# To Members of the Scarborough Planning Board

We, members of the Pine Point Community, are providing you with research we have done which we hope will help you as you consider the Lighthouse Condominium's Site Plan and the Town's Task Force Plan for the Abutting Parcel which the Site Plan Ordinance requires you review and issue an advisory opinion.

#### COMPARISON OF "DROP OFF" PLAN

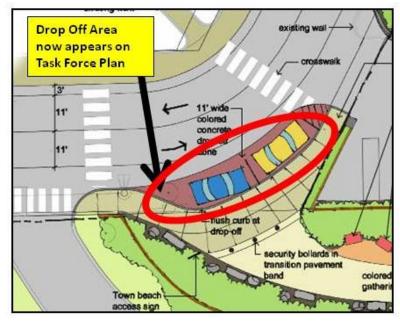
ABOVE: Wendel Sketch for 2008 Road Reconstruction Committee showing a "Drop Off" Area for Vehicles. The Committee Rejected the Drop Off Concept as unsafe and impractical. It now appears in the 2009 Task Force Plan below.

The drop-off holds some concern for Town Engineer Jim Wendel, who said Thursday morning that it could cause traffic problems.

"If it gets highly used, such that you get a high frequency of cars backed up that are trying to use the space, then you're going to be pushing traffic back into the travel lane and the potential is there to block the Beach Walk Drive," he said. "I couldn't say it will be unsafe, but it has the potential to become a traffic jam."

Planning Board Members: Please take note of Engineer Wendel's concerns about the Drop Off. He Expressed similar ones during the 2008 Road Reconstruction Study when an identical plan was considered but rejected and removed from the design. A separate graphic compares the two.

The Town Survey (just completed) showing the significant encroachment of the stone wall and backfill. The yellow line is the property line.

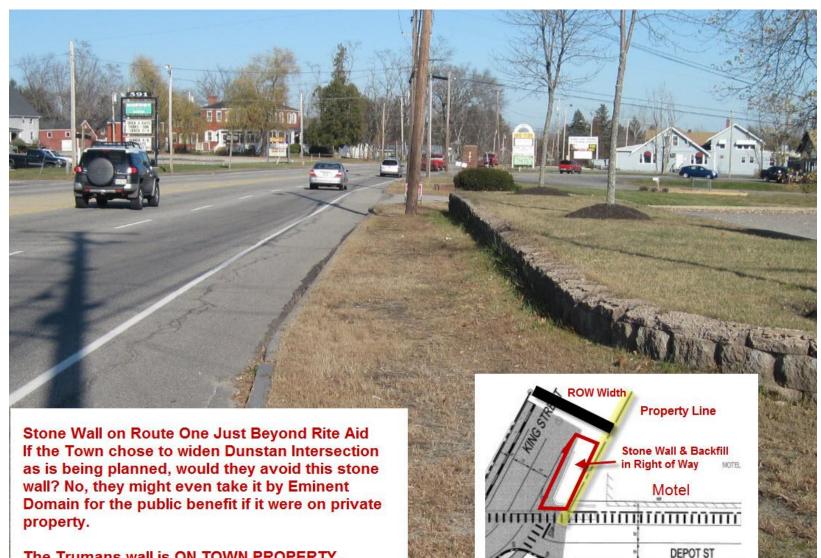
The primary concern about this stone wall was safety given the dangerous, heavily traveled curve. The encroachment itself was also a concern since it went far beyond the typical encroachment by the public of lawns, bushes,, etc.

The Town's reconstruction plan for this section of road did not include removing the obstruction which will result in a narrower road and additional safety considerations. The Task Force plan calls for a tiny piece to be moved, which is also evidence that the Municipal projects and the Truman's Site Plans are integrated and should receive your full review and approval.

You are urged to require as a condition of approval for the site plan removal of all encroachments and restoration of pavement on the right of way for the safety of pedestrians, bicyclists and motorists.

The Trumans wall is ON TOWN PROPERTY.

#### Wendel Plan: May 19, 2009 based on 2008 Committee's Final Recommendation.

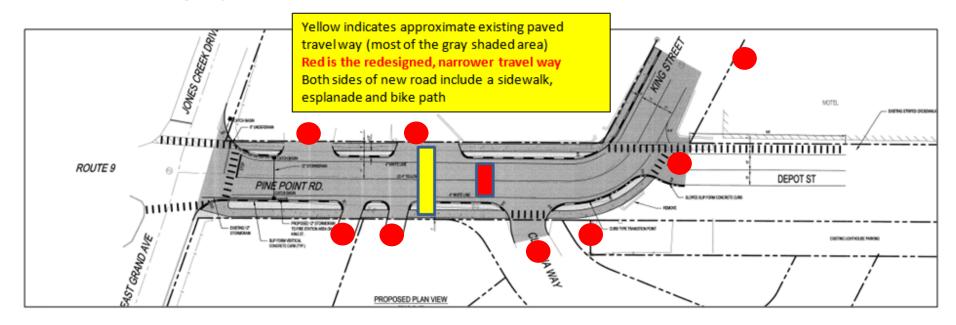
We believe you are very wise to consider the convergence of four major developments as they relate to the Lighthouse Condos site plan application. Below left you see Mr. Wendel's road reconstruction plan which also shows three curb cuts into the Beachwalk subdivision. The red dots indicate all curb cuts in this short piece of road which is the gateway to Pine Point and is heavily traveled by commercial traffic, boat, RV, Trolley, pedestrian, beachgoers destined for Hurd Park and, of course, Engine 4 which is just around the corner. The Lighthouse Condos Site Plan, we believe, should be considered in its relationship to the new road design (a much narrower paved travel lane), the Town's proposed walkway design, the Beachwalk's curb cuts, the proposed crosswalks, and the "drop off" design at the intersection.

TO:	TOM HALL, TOWN MANAGER
FROM:	B. MICHAEL THURLOW, FIRE CHIEF
SUBJECT:	DEPOT STREET ACCESS TO THE BEACH
DATE:	6/17/2009

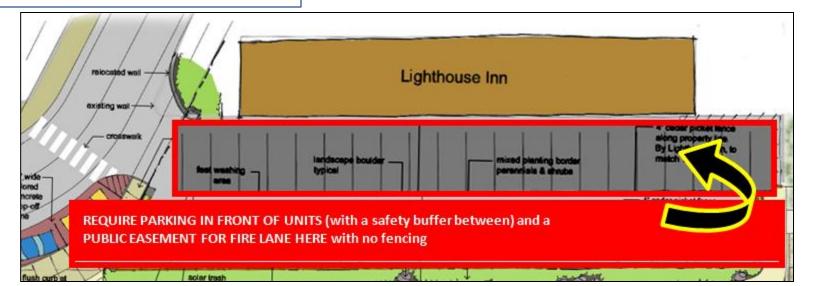
The Fire Chief was clear in his memo that a fire lane was very important in this area. Neither the Truman Site Plan nor the Task Force's Concept Plan includes one which meets the standard. Depot Street, before its closure, does.

It has been said that a fire lane will be provided on the Lighthouse Site Plan but that is not possible. Nor is it sound public policy for a fire lane to access public area go through private property.

Even though the department would likely not access the beach from Depot Street I believe it would be very important to maintain a fire lane for access as close to the beach as possible at that location in any design plans that are being considered for this area.

You are urged to require parking for the condotel be directly in front of the units and a public easement for vehicle access be granted by the Trumans for a fire lane.
